Plant: Turkey Point Unit 3

Performance Indicator: IE01, Unplanned Scrams per 7000 Critical Hours

Question Section

Resolution to FAQ 23-03 Revision 1, submitted March 26, 2024

Figure-1

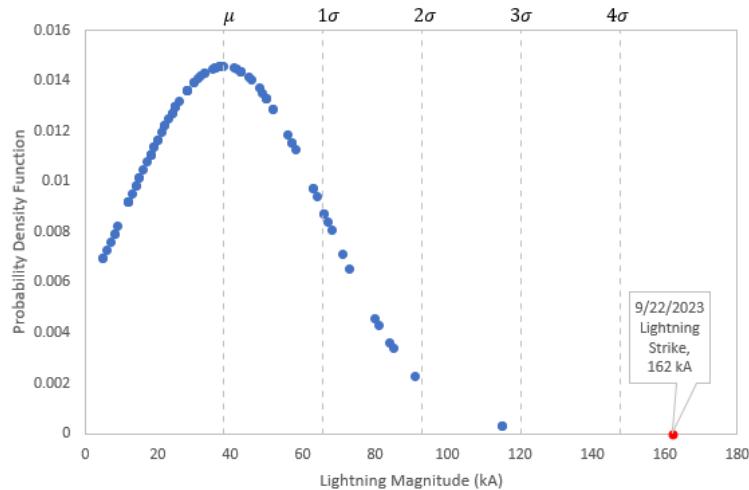
Figure-1 is based on a data set of lightning strikes occurring within a half mile radius of the Turkey Point switchyard over the last ten years. As is shown, this lightning strike was greater than four standard deviations (99.85 percentile) above the mean making this lightning strike an extreme statistical outlier.

The direct cause of the scram was the unprecedented magnitude of the lightning strike which created an induced voltage through the switchyard ground grid that arced across the string bus differential relay contact, resulting in a generator lockout. As the lightning strike itself was an extreme statistical outlier, this scram was caused by unique circumstances beyond FPL's ability to foresee or control and there is sufficient basis to warrant exception to the guidance as written in accordance with NEI 99-02, Revision 7, Appendix D, Page D-1.

Exemption from this event counting against IE01 “Unplanned Scrams per 7,000 Critical Hours” is not granted since scrams are a first step in a sequence that places reliance on equipment and human performance as responding mitigating systems, increasing the risk of nuclear accidents.
